4.3.2 Housing

4.3.3 Design

Planning Application - Third Floor

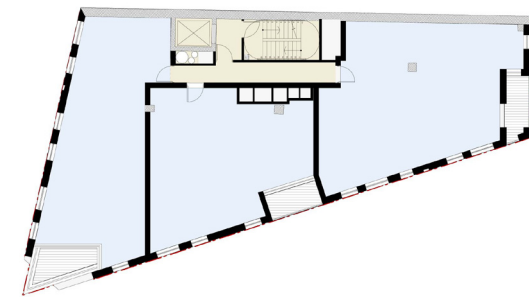
'Mix - At present the mix is not considered to be appropriate as the proposal provides too many 1 bed units for which there is lower demand. The proposal should contain a 40% two bed units and greater number of family units.'

Following the pre-application response we have increased the number of 2 bedroom units by providing three units on the third floor rather than four units. This has led to a revised total of 16 units with 6no 1 bedroom units (38%), 7no 2 bedroom units (44%) and 3no 3 bedroom units (19%) which meets the requirement identified within the pre-application response.

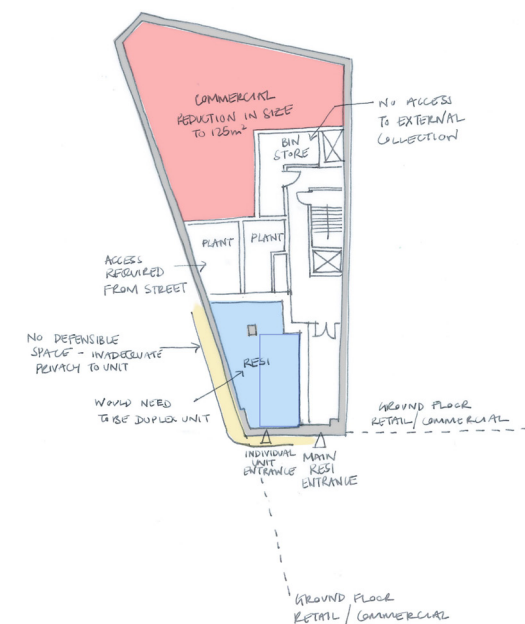
'Affordable Housing - Your scheme provides 1,228 sqm of residential floorspace as such a 12% contribution towards affordable housing would be required. In line with the requirements of the policy, the provision of affordable housing will be expected on site, but where this cannot be practically achieved on the site we may accept off site affordable housing or exceptionally a payment in-lieu.

The adjacent sketch illustrates some of the limitations associated with delivering residential at ground floor, and highlights the following design constraints:

- No defensible space along street level - It is therefore difficult to provide usable residential space at ground floor because there is no way of ensuring the privacy of a unit provided here. Security is also a potential issue.

- Insufficient space for a unit - Only c.35m<sup>2</sup> of residential space could be provided at this level so it is not possible to accommodate a unit in line with the London Housing Design Guide recommended areas in this location. In considering a duplex in this location, the privacy issues outlined above would result in a very inefficient use of space and an inability to comply with design standards.

Revised height of top storey for Pre-Application Meeting

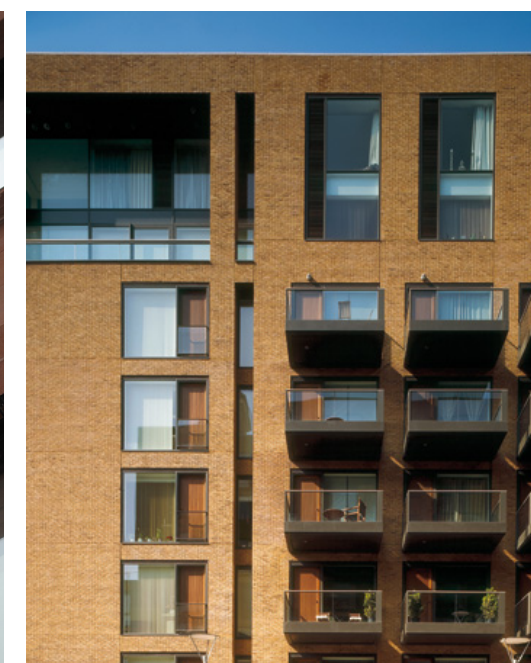
Concern is raised by the height of the proposed frontage building on Euston Road which is considered excessive in terms of height, bulk and scale particularly when seen in the context of the street scape on this side of the Euston Road. The proposed height will also have some impact on the long views of the Listed BT Tower which is clearly visible from this part of the Euston Road. As such, it is suggested that the proposal is amended by reducing the height of the building.’

**Reduction in height**  
Following our initial submission we reduced the height of the top storey by relocating the plant and reducing the parapet. This led to the height of the building becoming the same height as 365 Euston Road at the other end of the street block.

**Set back roof**  
In addition the top floor was set in, to reduce the height when viewed from the street. In order to provide a more subservient appearance to the upper floor, the material appearance and treatment was altered to appear different from the feature corner winter gardens.

**Separation between winter gardens and roof massing**  
The top floor increased the glazing and the metal finish has been shown as a light grey treatment in contrast to the dark grey powdered aluminium winter gardens. The intention was to futher recess the roof by providing a visual separation between the winter garden and the roof element.

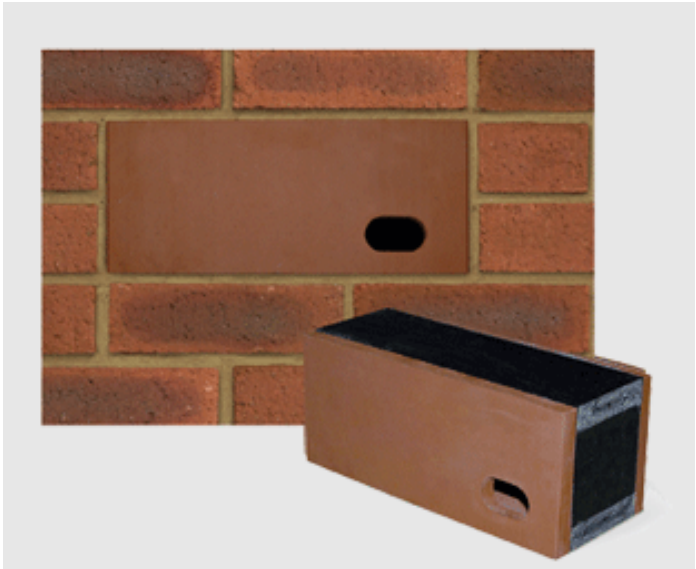
'The ground floor window opening to the retail units on Cleveland Street is considered to be excessively wide and does not relate to the fenestration at upper levels, it is suggested that this window is intersected with a vertical solid pier to help ground the building and the better integrate the design.'

Additional brick piers have been carried to the ground to provide smaller shop fronts with better integration to the fenestration above. In addition this provides a more sensitive relationship to the existing retail units further along Cleveland Street which provide smaller, individual commercial units. The fenestration at ground floor along Euston Road has also been reduced to ground the upper floors and provide a more evolved design.

Fifth floor plan with brown roof identified

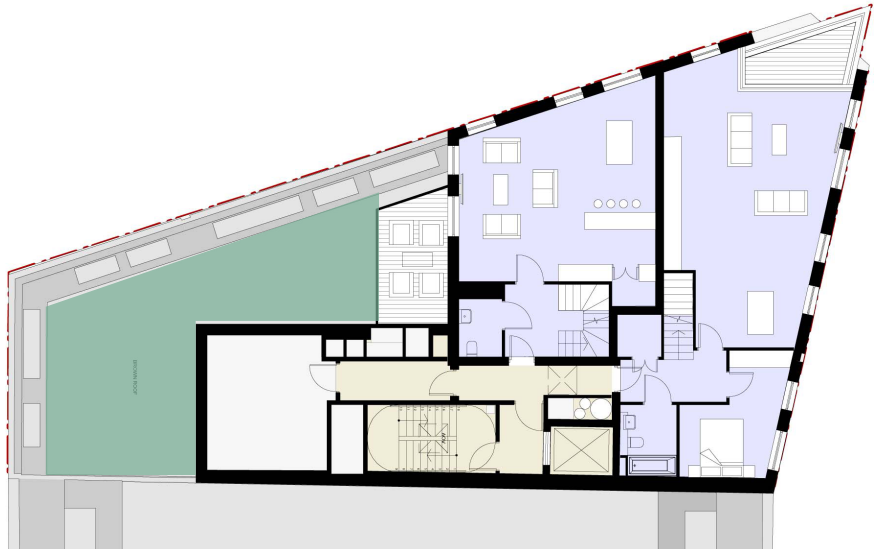
‘Any new development should incorporate biodiversity enhancing measures such as biodiverse roofs, green walls, bird and bat bricks in line with planning policy and guidance. A proposed roof plan has not been submitted with the pre-application documentation. You are advised the main roof of the building should be a green or brown roof. You are also advised to incorporate bird boxes into the design of the building, specifically swift bricks on the north elevation of the building.’

Following feedback from LBC we have incorporated a brown roof into the fifth floor roof. The brown roof is to be a lightweight extensive roof to create habitats by providing an environment that can be colonised naturally.

In addition we have included ‘swift bricks’ into the recess within the facade of the northern and western elevations. This allows the bird boxes to be integrated seamlessly into the design of the building while providing shelter for the birds using them.

Residential use along Euston Road

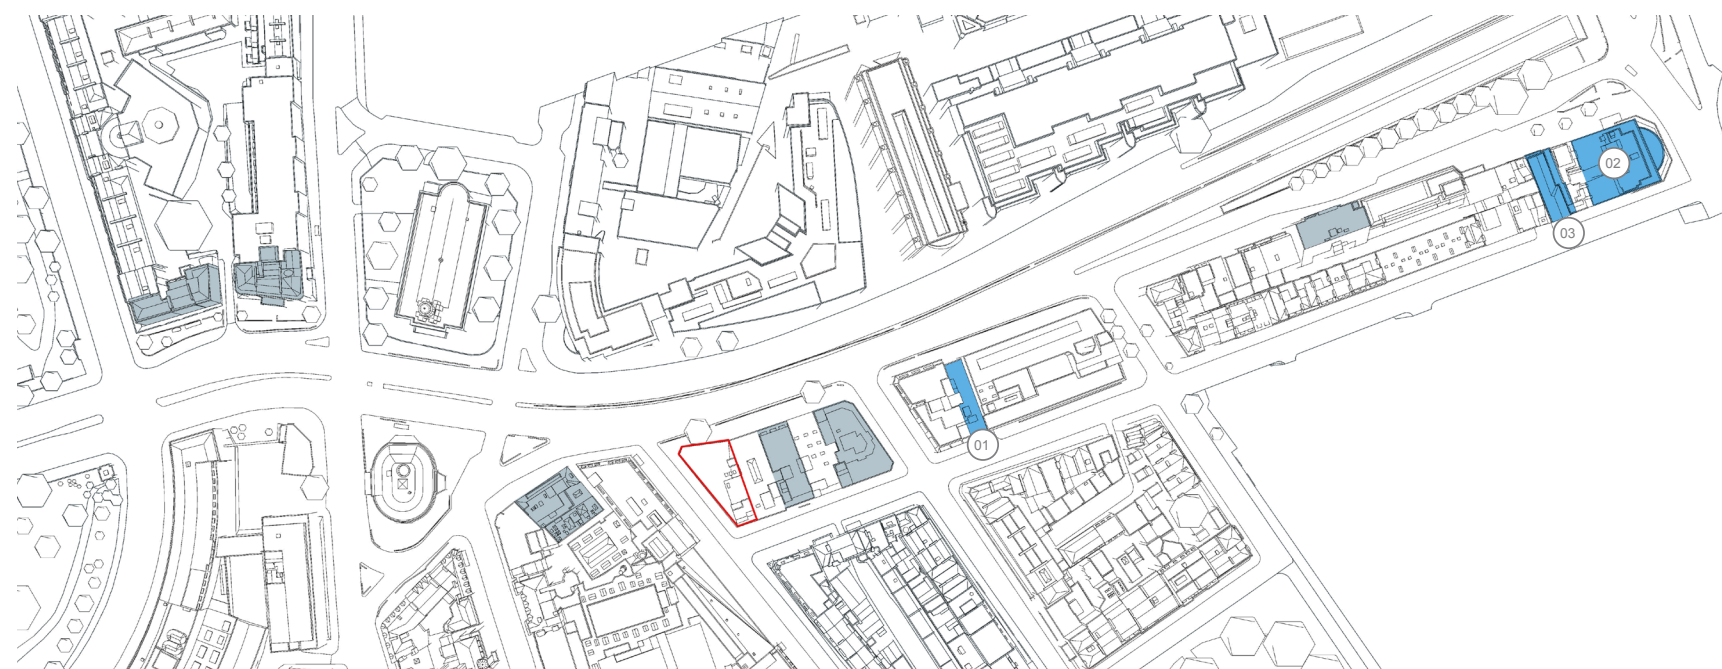
'The units to the front of the building would face directly onto Euston Road. These units would be dual aspect, however the windows on the side elevation would also be located very close to Euston Road. Euston Road is a major thoroughfare through London which has heavy traffic which emits high noise volumes 24 hours a day. You have advised that the new building and windows would be designed on to attenuate this noise. However, in the front flats even if this noise is attenuated it would not be possible to open windows to allow natural ventilation. This is disappointing and would result in the resident accommodation towards the front of the building being poor quality. It is suggested that you explore an alternative layout to improve the residential quality of the units.'

The noise levels and air quality levels along Euston Road and Cleveland Street require all units within the building to be mechanically ventilated through the use of whole house ventilation. However they have been designed with an acoustic consultant and air quality consultant to ensure all units have a good quality of residential accommodation. Please refer to the Acoustic Report and the Air Quality Assessment submitted in support of the application for further information.

In addition we have reviewed other residential accommodation within the area with mechanical ventilation to ensure residential accommodation designed in this way would be successful within the area.

Lower ground                      Ground

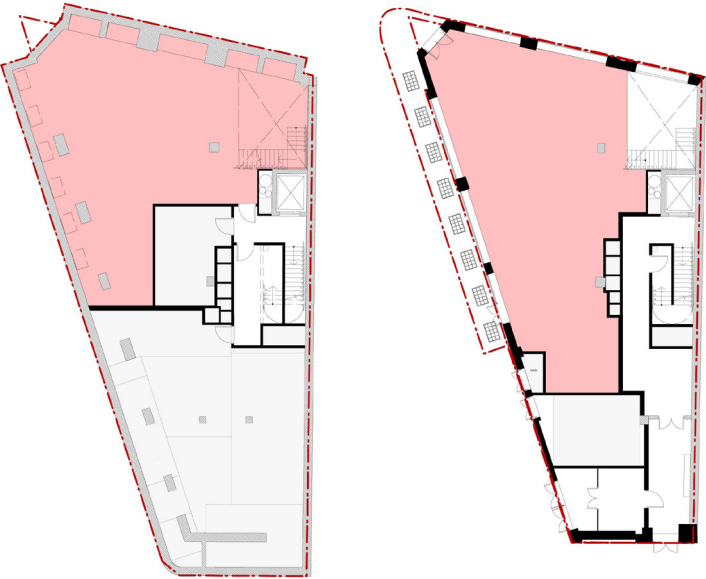
‘Car Parking - The original proposal included parking for the residential units in the basement and I advised you in the meeting that this would not be acceptable. As such, you have amended the proposal to remove the car lift and basement level parking (as shown on plan A2413-SK-1311-03-P2). This change is welcomed.

From a residential perspective we would use TfL’s Parking standards that stipulate that a minimum of one space is required for dwellings up to 2 bedrooms. For units with 3 or more bedrooms the standards require the provision of 2 spaces per unit. The proposal suggests providing 14 cycle storage spaces at basement level.

This does not meet the required number of cycle parking spaces. In total based on the current mix 20 spaces are required.

Following the pre-application meeting, the A1/A3 unit proposed has become an A1/A3/B1 flexible use unit at ground and basement level with the removal of the existing car lift and the proposed car parking at lower ground floor.

19 cycle spaces are provided within the basement in accordance with Camden Parking Standards. It is not possible to include cycle parking at ground level for the residential units due to the amount of servicing already occurring at ground floor and the limited street facade remaining for commercial use.

Cycle ramp

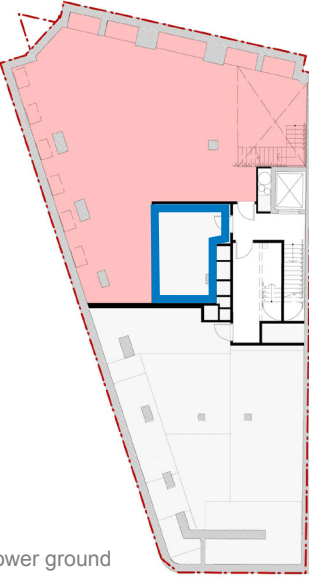
As outlined in CPG7, ‘cycle parking needs to be accessible (in that everyone that uses a bike can easily store and remove a bike from the cycle parking) and secure. The route from cycle parking to street level should be step free. Cycle parking inside buildings should be at the entrance level of the building or accessible by a ramp or lift from street level that can accommodate a bike’. It is noted that a lift is being proposed to take cycles down a level to the basement where cycle storage is proposed. You should demonstrate in any application that all other avenues to host the cycle provision at ground floor level have been exhausted.’

However a bike wheel ramp will be provided on the side of the stair to the basement to allow easy access for cyclists. The cycle store is to be secure.
